**RIO MESA RESOURCES INC
GOVERNMENT-61N102W 1SWSW
Location # 315092**

COLORADO
Oil & Gas Conservation
Commission
Department of Natural Resources

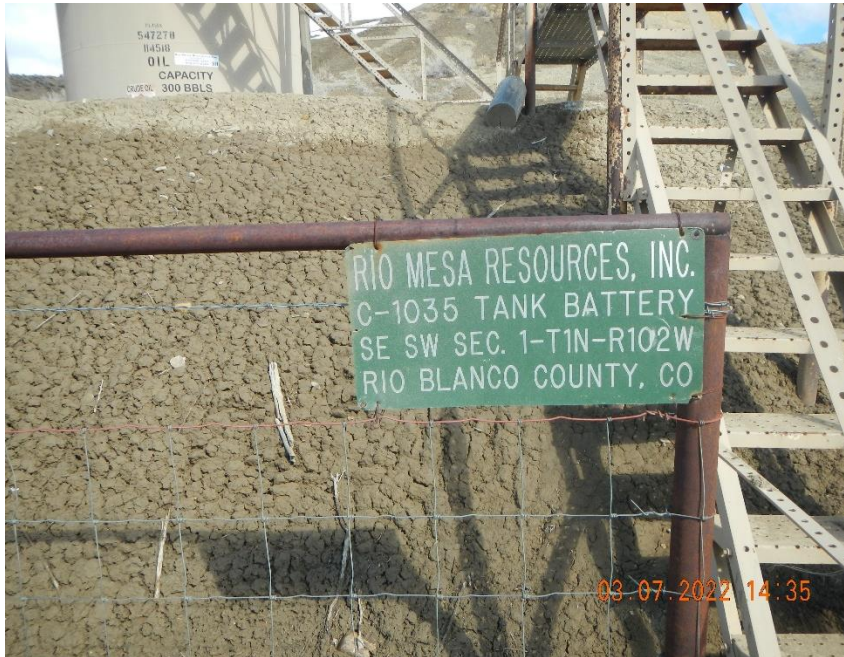
Tank battery doesn't meet Rule 605.e..

Base of berm is marshy.
